Proposed Design - Pre-Application Feedback

A Pre-Application enquiry (23//0032/PREAPP) of an earlier design iteration which had a larger footprint on site and was closer to its boundaries was submitted on 11/04/23. The present proposals have responded to each of the feedback points noted below. The key changes have also been shown in annotation on the layout diagram on page 29.

Part 1 of feedback received by email on 02/08/23:

Clipped eaves is a traditional detail that can be seen in Beer

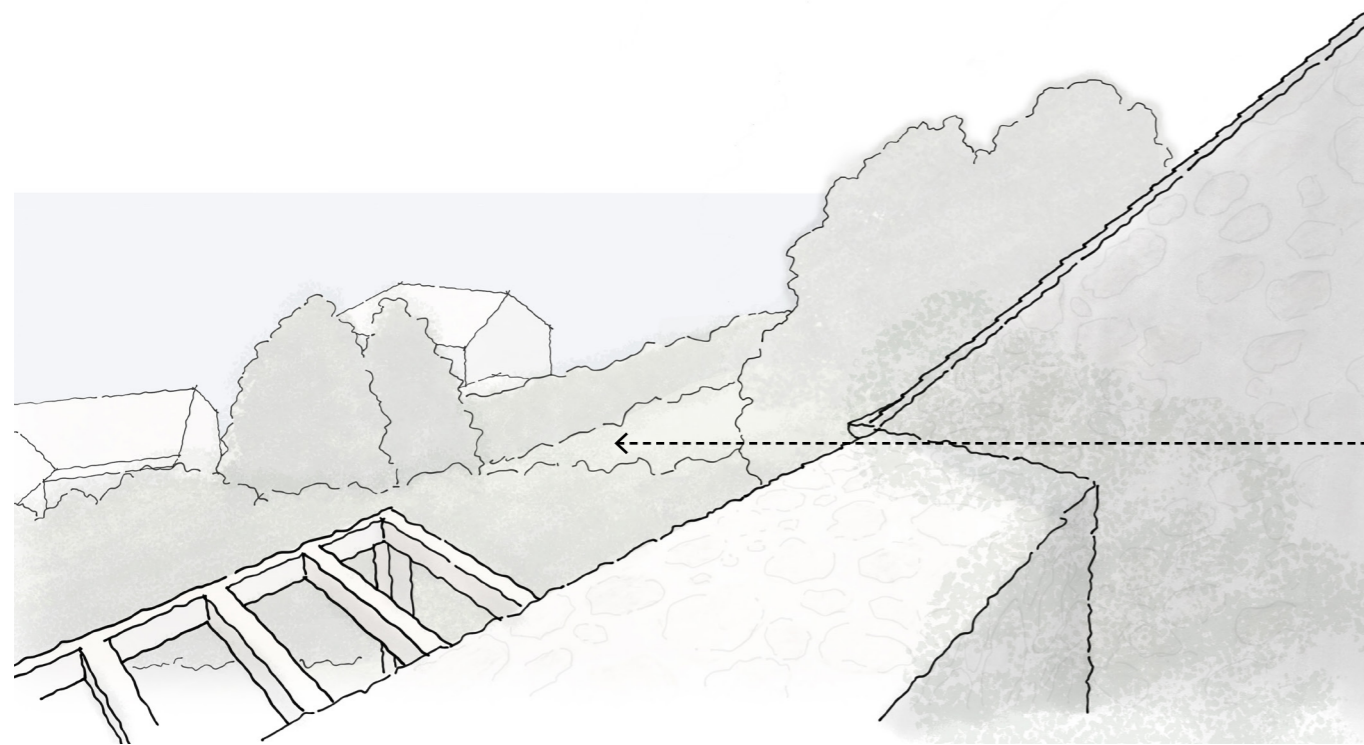
The eaves of the gabled buildings appear clipped and flush with the main building. It is unclear if this is intended to be part of the design (and if so, how it would allow rainwater to be dealt with). It is suggested that if the clipped eaves are to be part of the design, then this should be referenced in a supporting Design Statement.

The proposal incorporates clipped eaves, a traditional detail which has previously been used in Beer, please see example opposite. This detail will have a very small tile overhang, tight up against this will be placed the gutter and downpipes which will deal with the rainwater.

Sketch view from first floor balcony

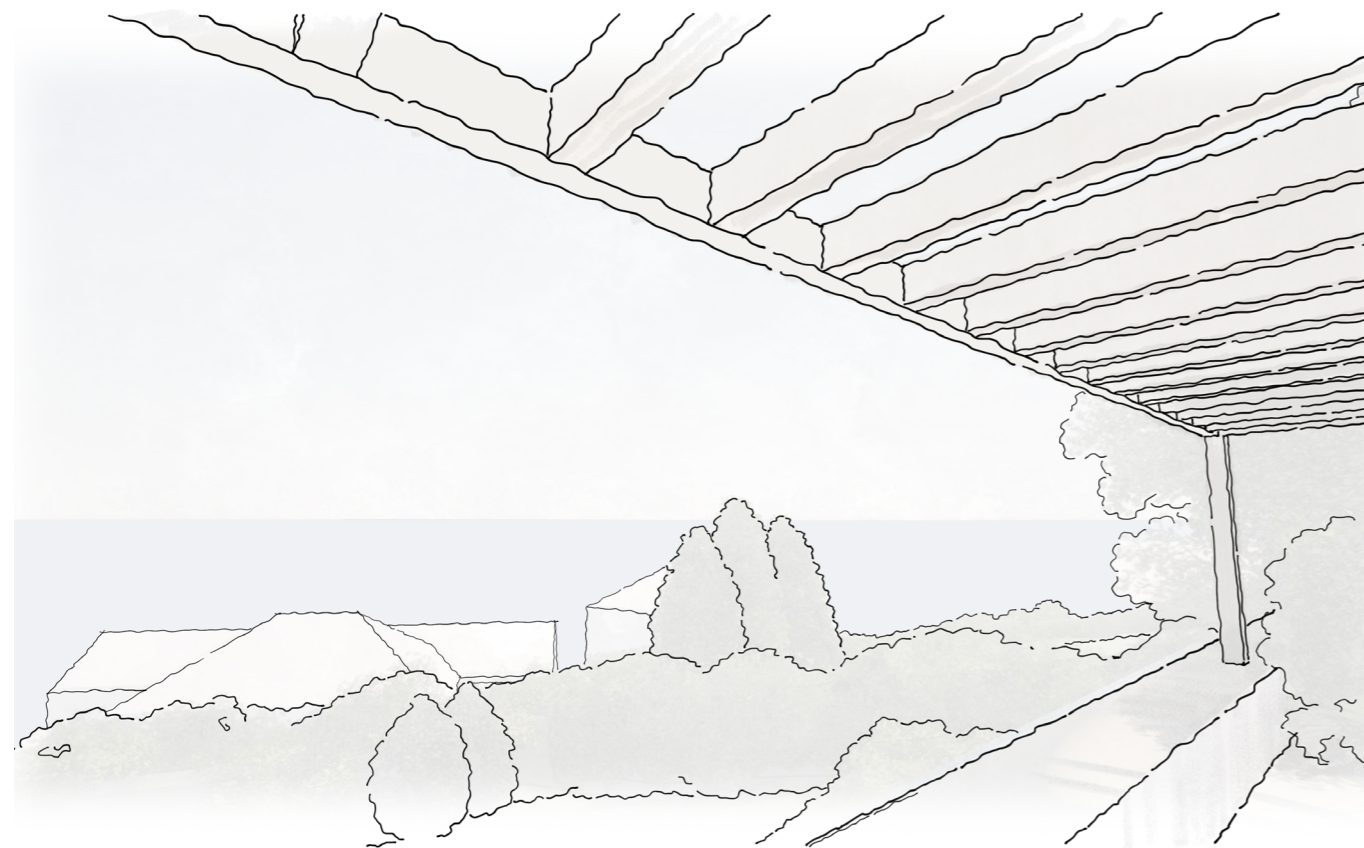
Clarification was sought over the potential for impacts on the privacy of neighbouring dwellings in relation to overlooking into dwellings and private areas of gardens. Clarification/information was sought on window positions and the terrace/balcony, site levels and between existing and proposed.

Only a small part of the lower end of Southdown's garden will be visible. The neighbours gardens will remain private.

The roof slope framing the first floor balcony restricts any views from the interior of any of the neighbouring sites (please see sketch visualisation opposite). With the reorientation of the proposal the views when out on the first floor balcony are now also limited by the slope of the hill and the tall hedges running around the sites boundary. The only neighbouring garden to be visible from this viewpoint is the bottom end of Southdowns garden (please see sketch visualisation opposite) which is an area of shrubs and hedging.
